PROPOSED SETBACKS STANDARDS

PROPOSED BUILT FORM STANDARDS

(with Cl. 58 requirements)

Plan (Proposed Standards for Testing Diagram) - 40 Whitehorse Road

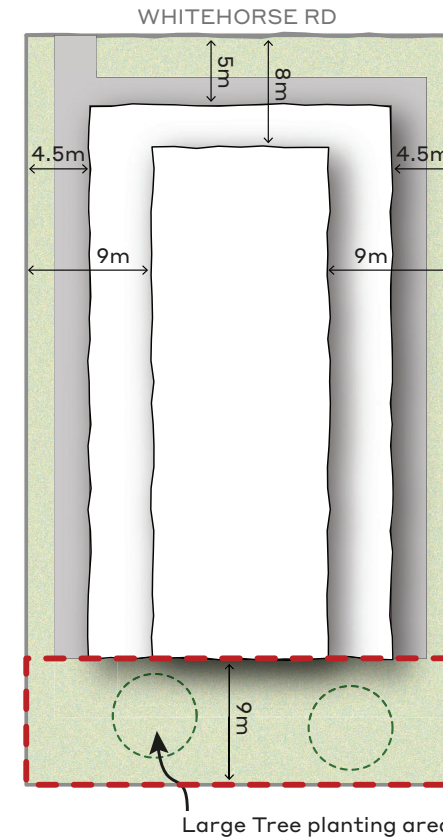
| Large Tree Area - | 0m ² (0%) of the total site area can be used for large tree planting (non-compliant with cl. 58.03-5) | Large Tree Area - | 275m ² (17%) of the total site area can be used for large tree planting (Provides 7% additional large tree area than what is required under cl. 58.03-5) |

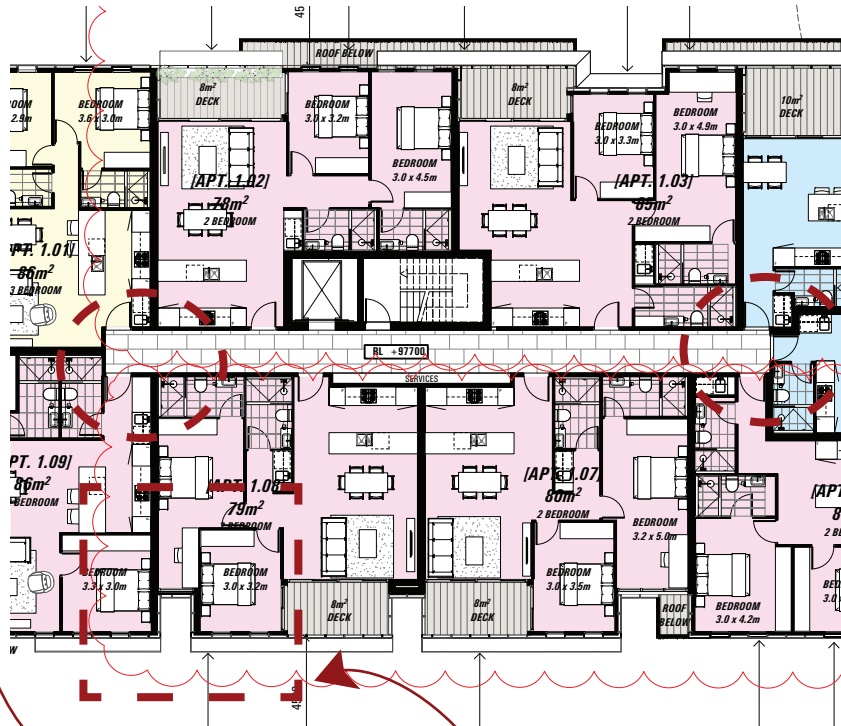
Cl. 58.05-2 Building Entry and Circulation Objectives- This internal building layout does not comply with Standard D18 - Provide corridors with at least one source of natural light and natural ventilation

Cl. 58.07-3 Windows Objective
- Snorkel windows with a depth greater than 1.5 times the width and not clear to the sky does not comply

Plan (Proposed Standards for Testing Diagram) - 260-262 Burwood Hwy

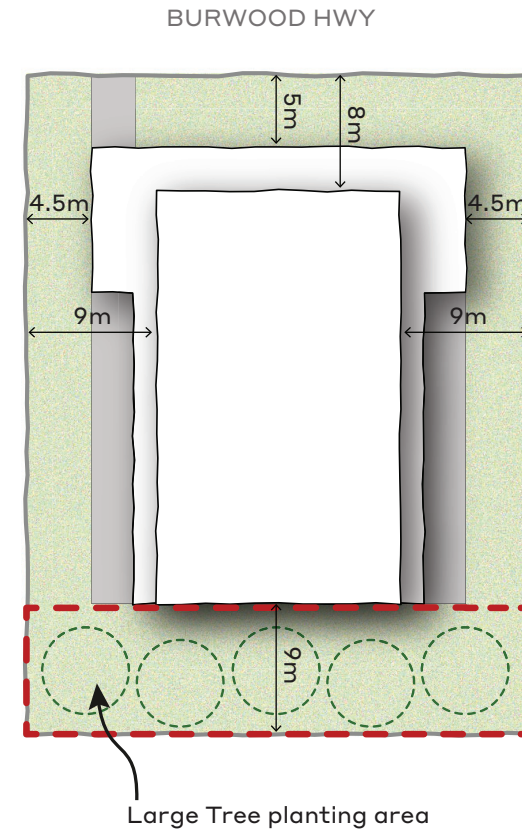
| Large Tree Area - | 120m ² (7.6%) of the total site area can be used for deep soil planting (non-compliant with cl. 58.03-5) | Large Tree Area - | 313m ² (20%) of the total site area can be used for large tree planting (Provides 10% additional large tree area than what is required under cl. 58.03-5) |
